GW - _____ 001 _____

TANK TESTING

From: Chavez, Carl J, EMNRD
Sent: Thursday, August 23, 2012 9:24 AM
To: 'Schmaltz, Randy'
Cc: Weaver, Ron; Hawkins, Larry; Robinson, Kelly; Perrin, Charlie, EMNRD; VonGonten, Glenn, EMNRD
Subject: RE: Tank #12 Floor Replacement (GW-001)

Re: Western Refining / Bloomfield, NM
Landmark Job No. 1362
Tank 12 Bottom Repairs
"El Segundo" Style Bottom

LANDMARK			Floor Layout	
1665 Harmon Road, Ft Worth, TX. 76177 817-439-0022				
Rev.	Revision Description	Date	JOB 1362 BLOOMFIELD, NM. TANK 12 LEAK DETECTION	
1	Add 80 mil HDPE Liner	8/14/2012		
			Date	8/14/12
Submit	Approved by	Date	Sketch	N/A
T.J.B.R.		8/14/12	CHK.	JDN
			Date	KJN
			1362-R2

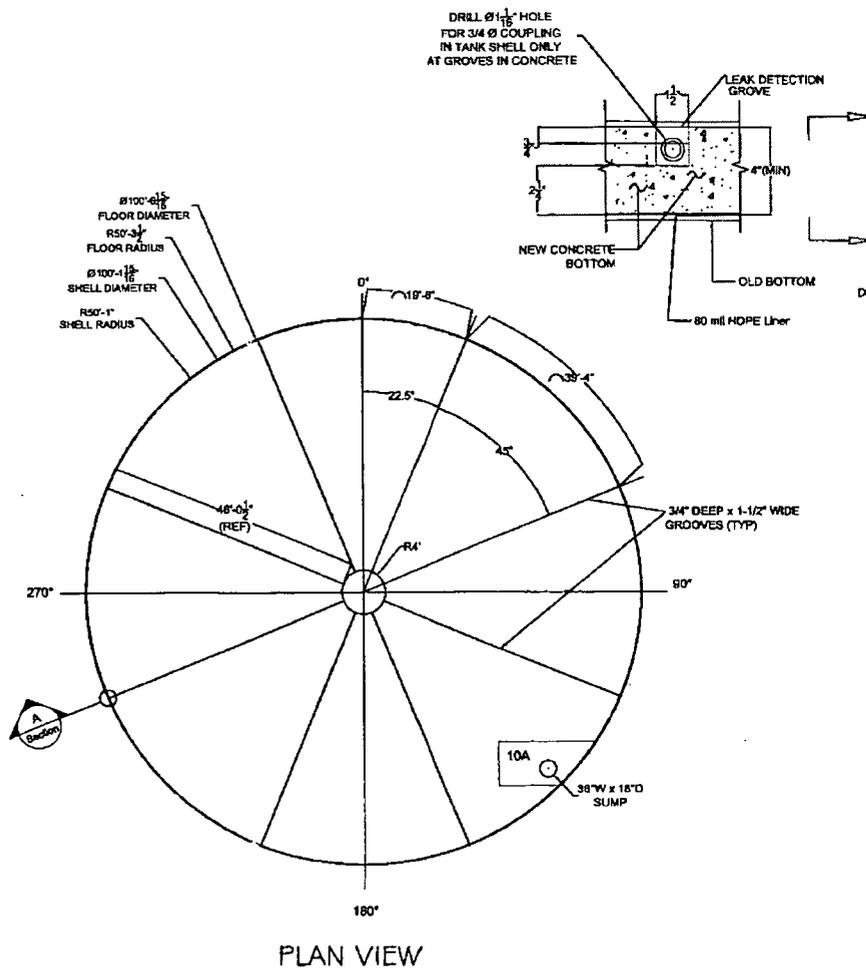
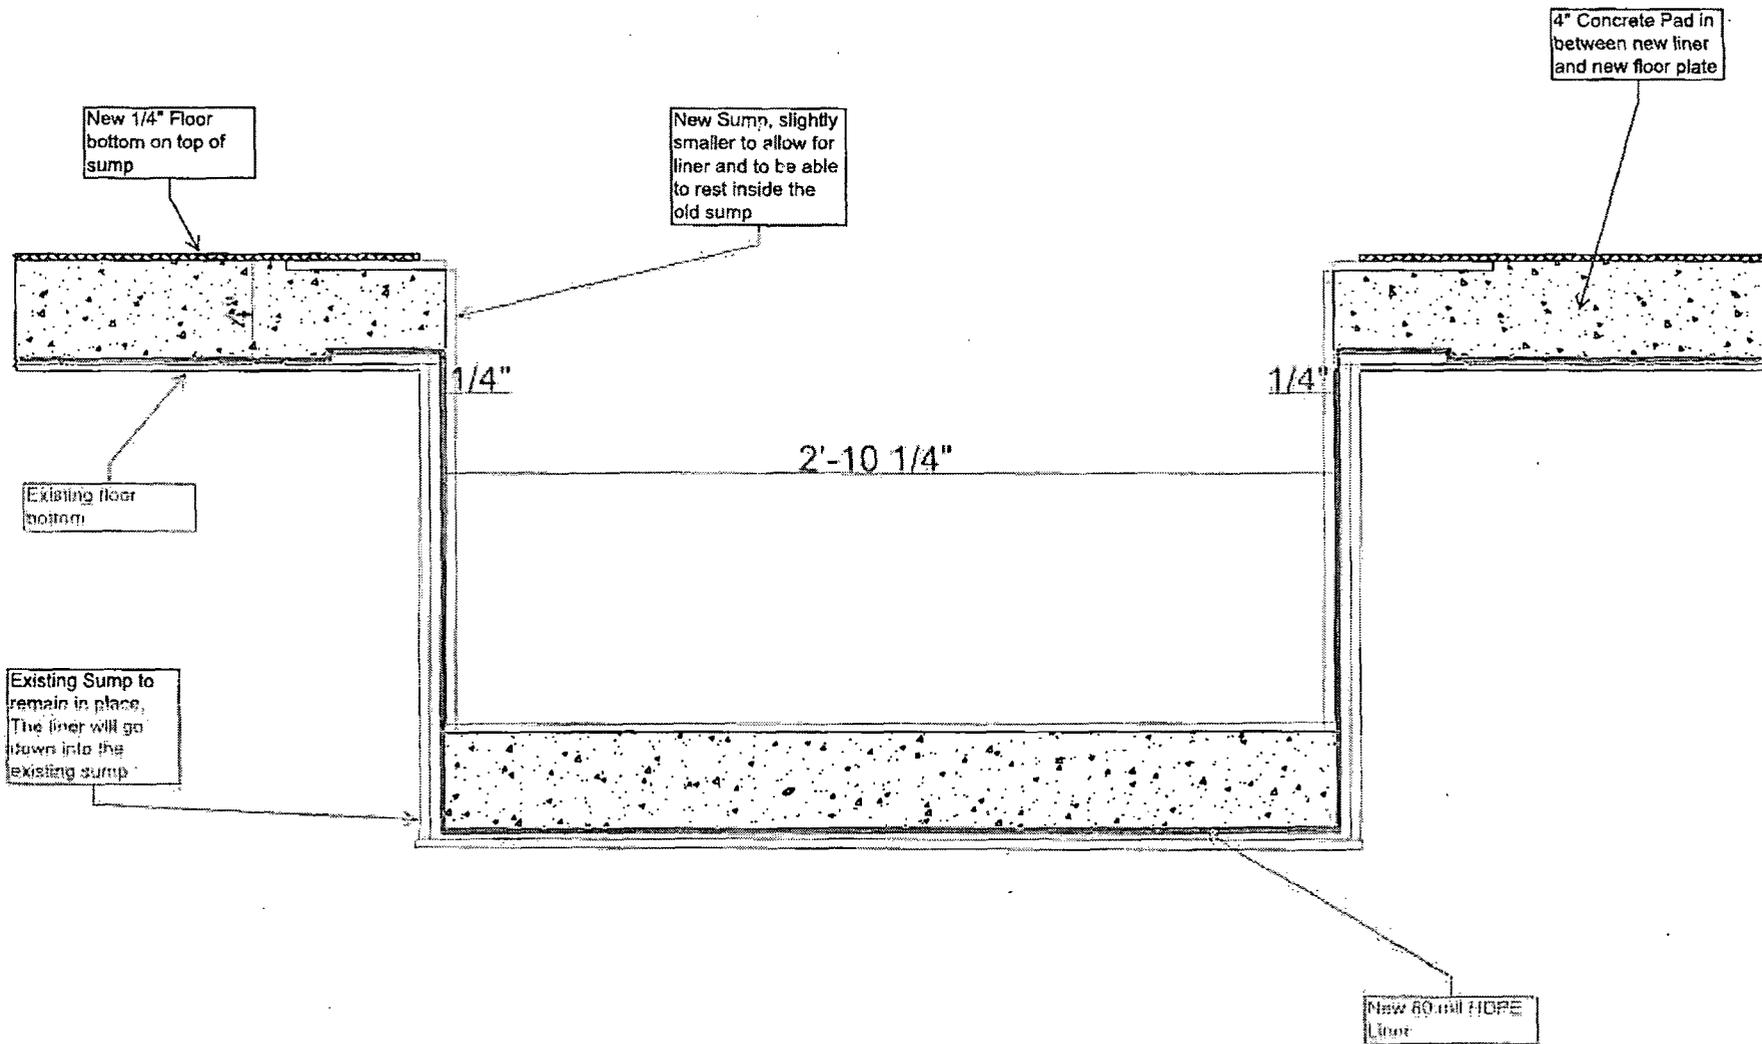
The OCD hereby **approves** the Tank #12 Floor Replacement proposal. The OCD notices that any leakage from the tank would drain into the unlined berm area, which the OCD recommends also be lined.

Please report any tank leak discoveries (before and/or after construction from testing) and comply with the berm requirements stipulated in the DP below. In addition, please update the facility tank work schedule spreadsheet to reflect the retrofit date, etc.

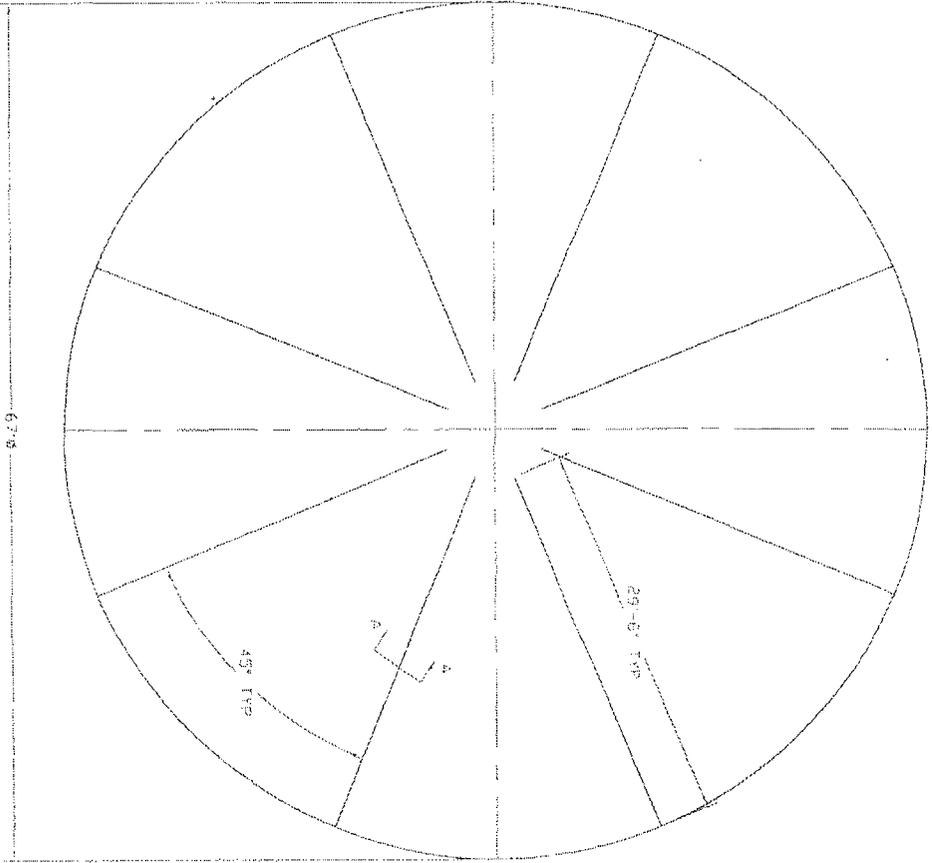
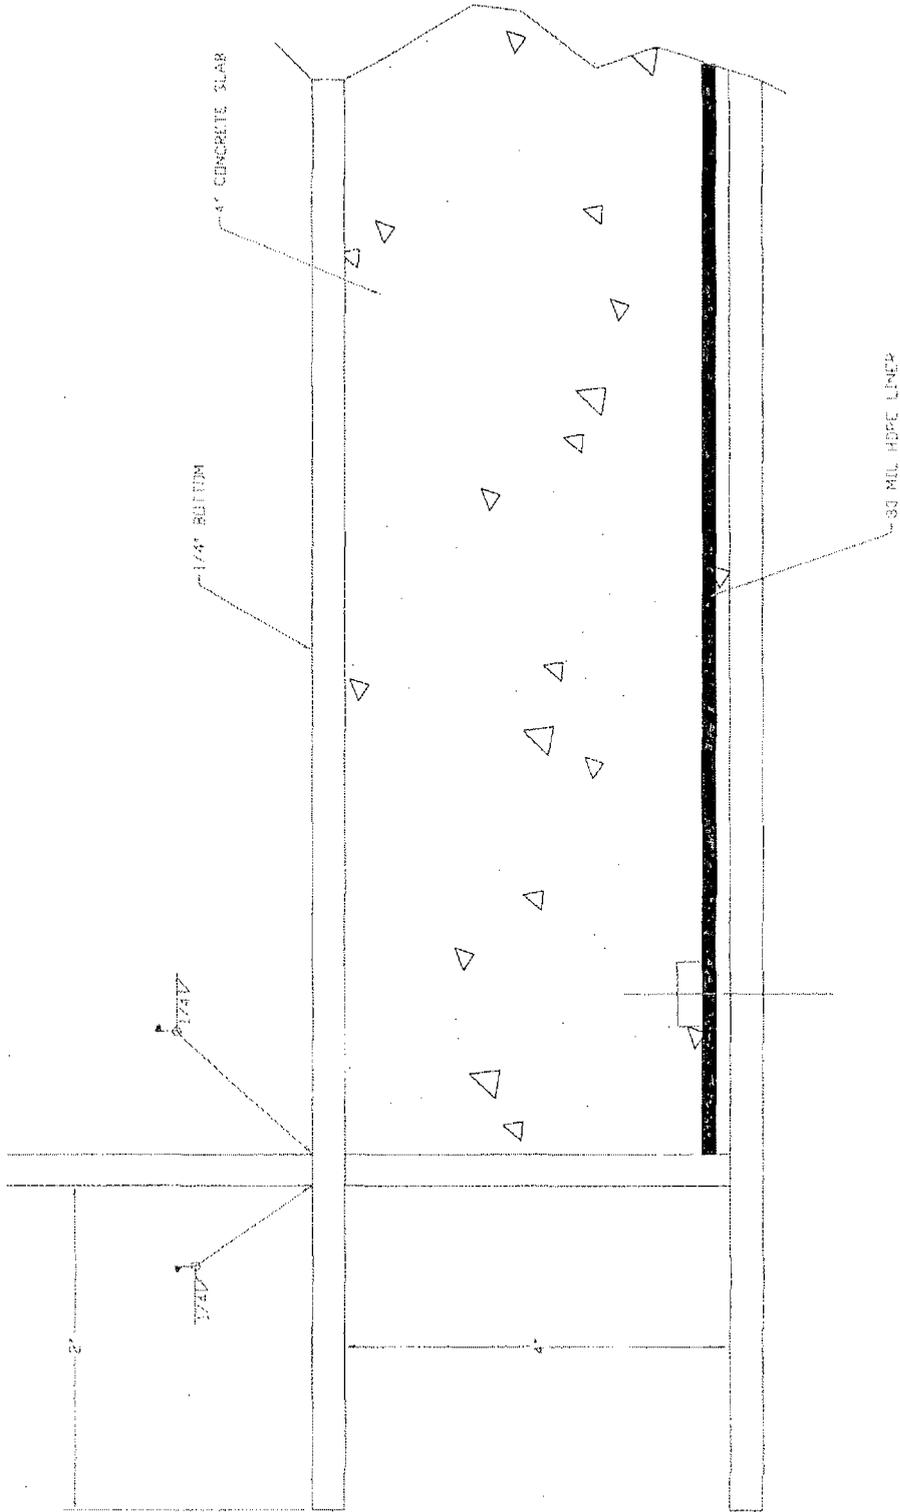
I appreciate the communication on the new Tanco Engineering Inc. (Tanco) tank bottom replacement design for the gasoline tank (Tank #13) where Western Refining attempted to complete repairs (patches, welding seams, etc.) on the tank bottom from metal loss, etc. discovered during a scheduled API inspection of the tank. After attempting to place the tank back into service (an MIT was likely performed), a leak was noticed and Western obtained an engineering design from Tanco. While the design lays out the basic engineering design, the structural and engineering details on the construction of the concrete design with grooves was not specified in your submittal.

The OCD requests a write-up on how the cement will be constructed (will grooved concrete sloping downward from the circumference of tank appear as a tube or wedge hold along perimeter of the tank concrete?) and engineering construction of the 4 inch concrete above the failed tank bottom. The OCD is concerned about preferential cracking along the grooves from the bearing load in a layer of concrete 4 inches thick with grooves in the cement. .

The OCD also requires a statement by a Certified Engineer that the construction design (i.e., 4 inches of cement) with the designed grooves set at 45 degree angles above the failed tank bottom will not fracture under full load of the filled gasoline tank.

Tanco is currently install at concrete double bottom in your 67' diameter tank is Bloomfield, NM. This "El Segundo" bottom consists of a HDPE liner over the existing ¼" floor plate, 2" minimum of 3000 psi fibermesh concrete and a ¼" floor plate. This particular double bottom configuration was originally installed in California in the early 1980s and for thousands of tanks since. It is detailed in API 650 Appendix I figure I-4.

The benefits of this configuration is that the concrete does not require any cathodic protection since all water is drained out of the tank floor due to the slope. The thickness of the concrete is irrelevant since it is not stressed except for the product weight. This product weight is only 20 psi. The concrete is in compression and rated for 3000 psi.
